75
SEABROOK STATION
Engineering Office:
20 Turnpike Road
Westborough, MA 01581

SB-7984
T.F. B 4.2.5

Subject: Pipe Support Base Plate Designs Using Concrete Expansion
Anchor Bolts

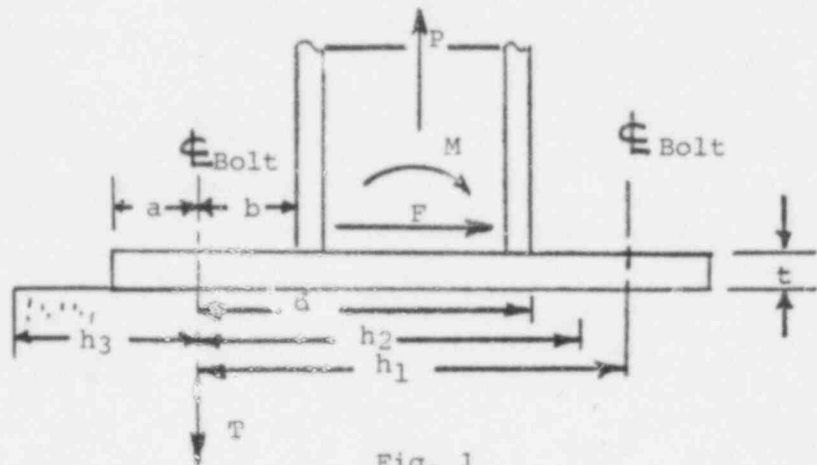
Calculations will be reviewed to assure that the effects of plate flexibility have been accounted for in the determination of anchor bolt loads. When the plates have been determined to be rigid (i.e. the distance from the edge of the support member to the edge of the plate is less than 2 times the thickness of the plate) the compressive force is assumed to act at the centerline of the anchor bolts on the compression side of the plate. Otherwise the plate will be assumed as flexible and the compressive force will be placed closer to the supporting member. The effects of 'prying action' in causing additional anchor bolt loading will be considered. A straight line shear-tension interaction will be assumed in determining anchor bolt capacity reduction when both shear and tension act on the anchor bolts. Minimum edge distance and anchor bolt spacing will be per the manufacturer's recommendations. When anchor bolt spacing and/or edge distance are not within the manufacturer's recommendations the load capacity of the anchor will be reduced in accordance with the recommendations of the manufacturer.

The approach used to calculate anchor bolt load for a typical pipe support base plate configuration is provided below:

$$T = \alpha_i \left(\frac{M}{N_1 h_i} + \frac{P}{N_2} \right)$$

$$V = \frac{F}{N_2}$$

- Where: T.V. Anchor design tension and shear loads.
- M, F, P Moment, shear and axial force acting on the connection.
- N_1 Number of tension anchor bolts.
- N_2 Total number of anchor bolts.
- i Index to identify base plate flexibility
($i = 1$ rigid, $i = 2$ flexible)
- α_i Factor to account for prying action for given plate flexibility.
($\alpha_1 = 1.0$, $\alpha_2 = 1.2$)
- h_i Moment Arm
- h_1 = Center line distance between bolts.
- $h_2 = d + 2t$ (not to exceed h_1)
